Findings, Conclusions and Decision Public Works Variance EN-22-0050

Site: The Reserve Preliminary Plat
Parcel No. 0222323134

Re: **(EN-22-0050)** The Reserve Preliminary Plat Cul-de-Sac Variance - Public Works
Variance Request

RE: The Reserve — CPH Project No. 0228-21-001
Request for Public Works Standards Variance for a Cul-de-Sac as a Road End
City of Gig Harbor Permit No. EN-22-0050

EXHIBIT A3 - EAST SITE PLAN

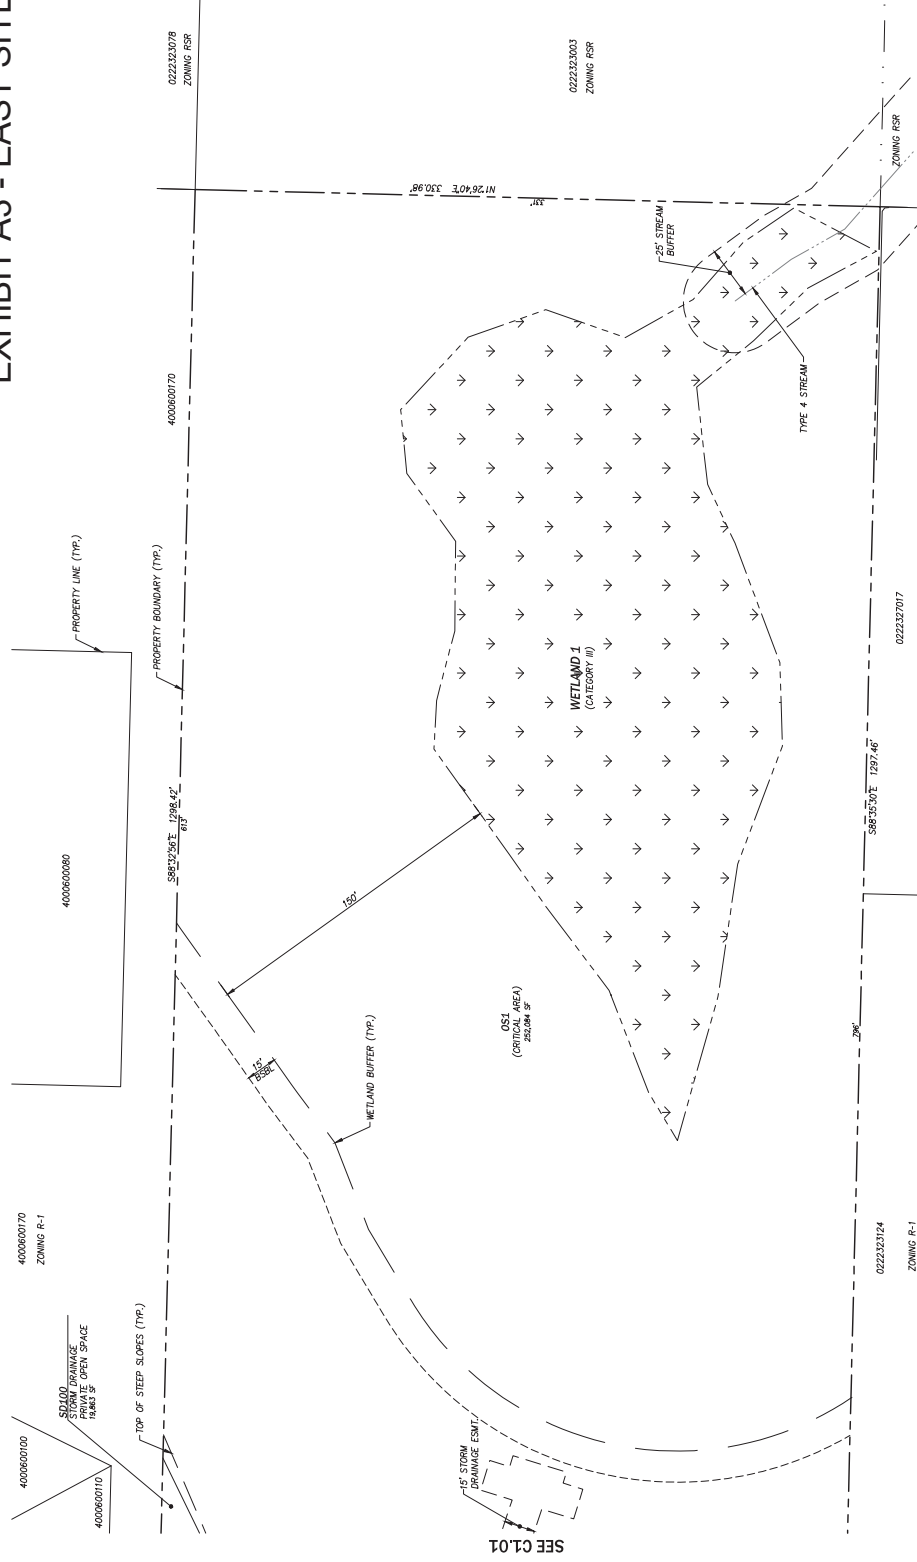
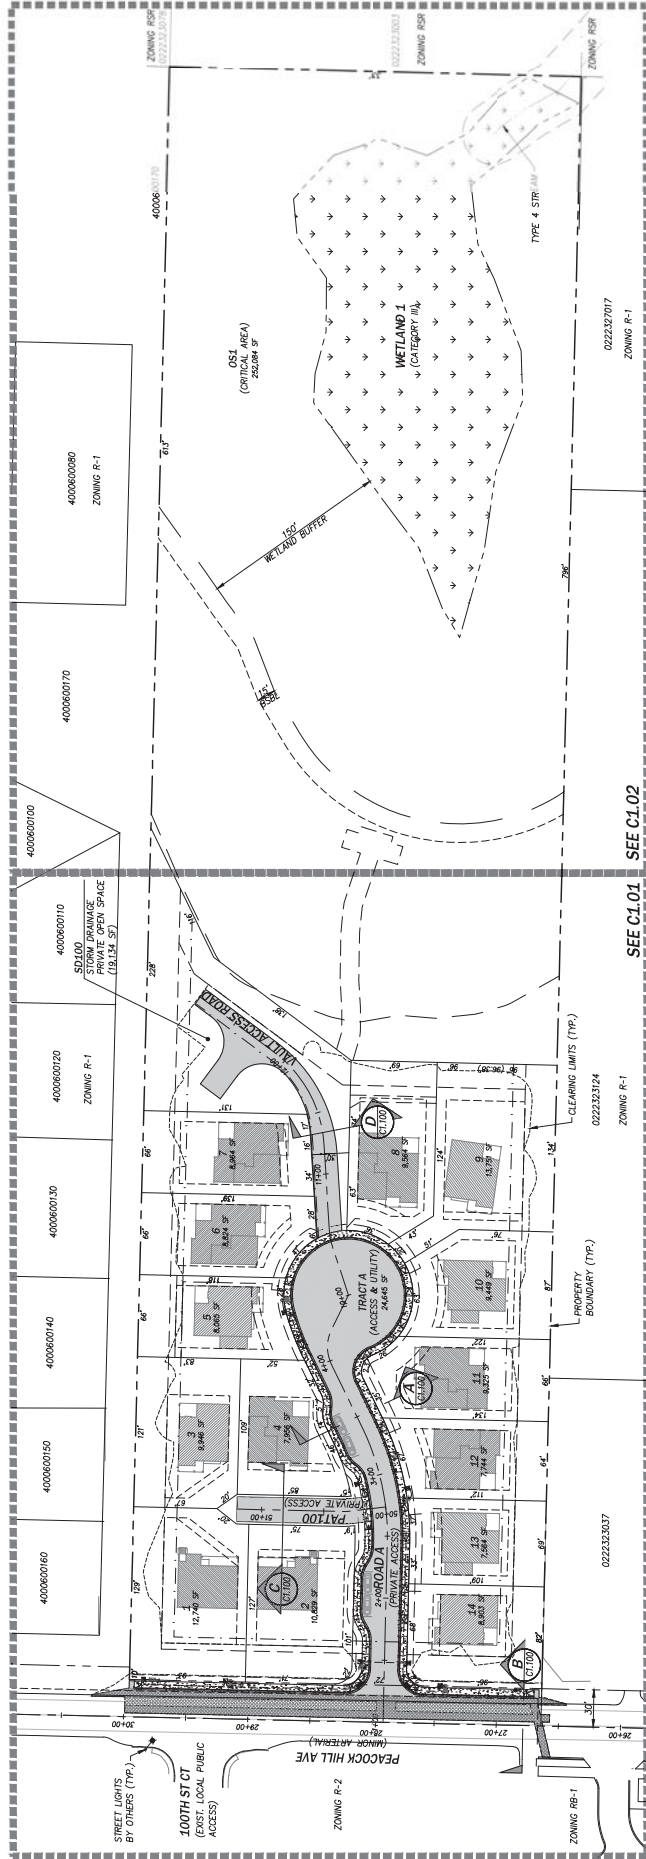
This letter and the enclosed site plan are provided on behalf of Prospect Development to request the City's review and approval of a *Public Works Standards Variance* for the proposed Road A to end in a cul-de-sac for the proposed 14-lot subdivision known as The Reserve (**PL-PPLAT-22-0001**). The requested Variance would allow deviation from providing a future roadway connection to another potential development or public roadway system.

The Reserve site has significant topographic relief that under existing conditions falls at an approximately 15% grade from the existing edge of pavement approximately 17 feet from the centerline of Peacock Hill Avenue NW to approximately 500 feet east in the site where steeper slopes as high as 45% exist. The project parcel is borderer by residential developments that exist north and south, a public road to the west, and a wetland east. This cul-de-sac will be used due to no future connection points within this project parcel and to provide an emergency vehicle turnaround per fire department code. Please see the attached site plan exhibits for reference.

The proposed variation is consistent with the intent of PWS 2B.090 because of the geographical conditions of the site. This cul-de-sac will comply with the minimum 45-foot radius (Standard Detail 2-11) and effectively convey runoff to the storm vault and provide access for residents, emergency vehicles, or maintenance personnel to access and leave the site. If this variance is denied, the result will be similar, except with the loss of a residential unit, additional fill required pushing the earthwork more out of balance and resulting in an idle future extension that does not appear to have any practical potential for being used.

For the Reserve Preliminary Plat Cul-de-Sac Variance request, the Gig Harbor City Engineer concludes that the variance satisfies all the Criteria for Approval and therefore approves the variance request. Any modifications to the proposed development may nullify or require re-consideration of this approval, at the sole discretion of the City Engineer.
